PLANT NAME: Midland 1 & 2

Consumers
Power
Company

February 3, 1976

MIDLAND PROJECT
DOCKET NUMBERS 50-329, 50-330
REGULATORY GUIDE IMPLEMENTATION
FILE: 0505 SERIAL: 2121

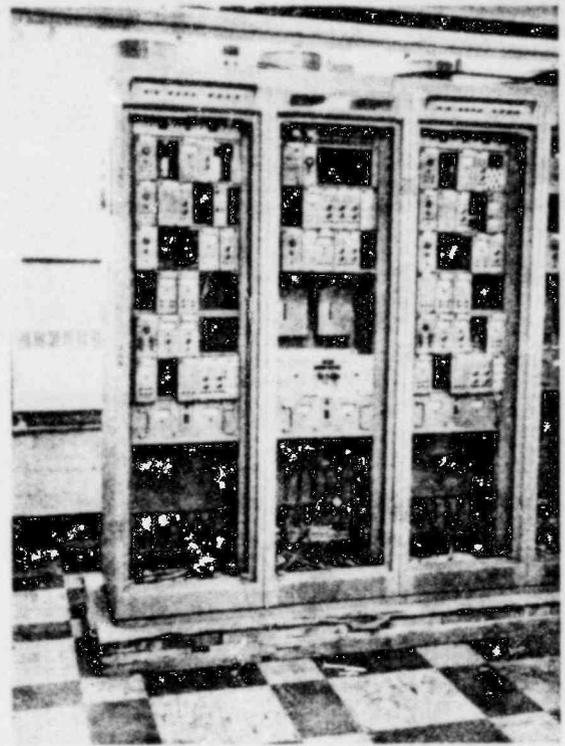
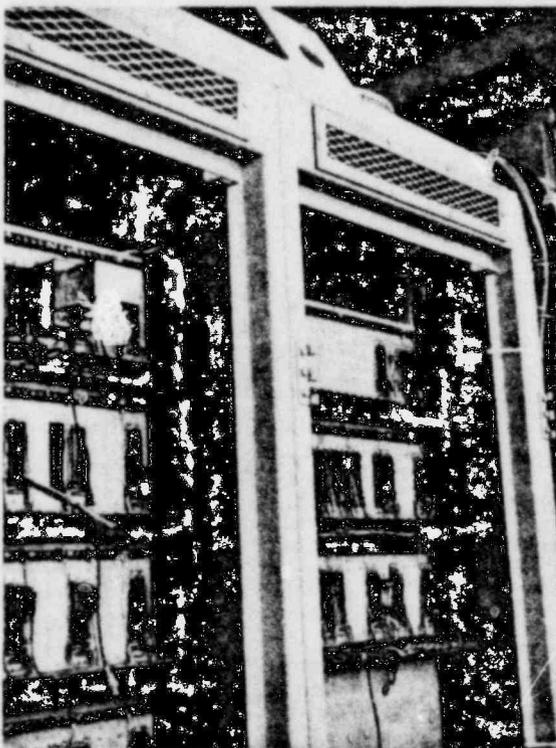
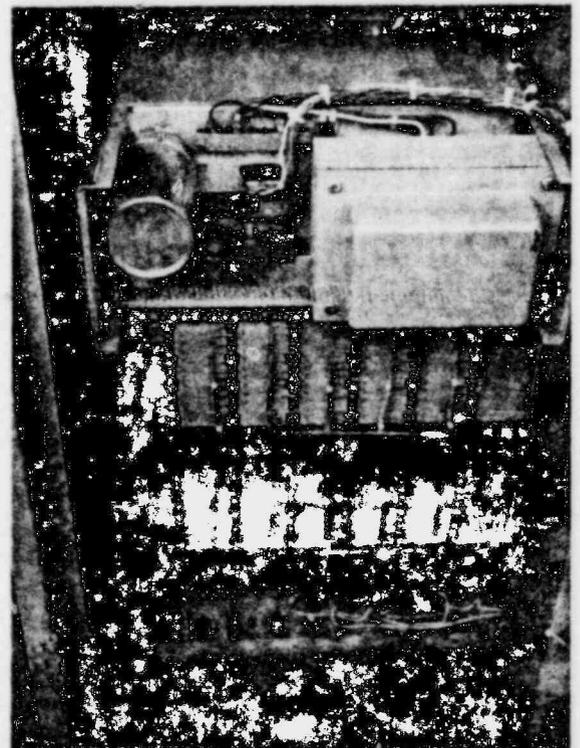
221.4 Due to the degree and number of areas of exception you have to Regulatory Guide 1.75, we require additional information to complete our review. As part of your response, the following information should be provided:

1. Basic criteria included in the plant design.
2. Sketches and drawings that define the areas of your design where exceptions exist.
3. A supporting discussion that explicitly defines these areas and degree of conformance.
4. In case of equipment in fabrication or fabricated, photographs are acceptable in lieu of sketches and drawings.
5. Justify exceptions to the recommendations of the Regulatory Guide.

- 2, 4 Photographs showing pertinent equipment features are included in this submittal.
3. Supporting discussion explicitly defining the areas of interpretation or exception and degree of conformance, is provided herewith as follows:

Front view of NI/RPS (3 channels) showing physical separation provided by cabinets (front doors removed during manufacture) and modular design. Each channel consists of two cabinets.

Closeup of cabinets showing field cable connection terminal strip area at bottom of cabinets (wires shown are for system checkout during manufacture).

Rear view of cabinets showing module back-plane internal wiring and physical separation provided by cabinets.
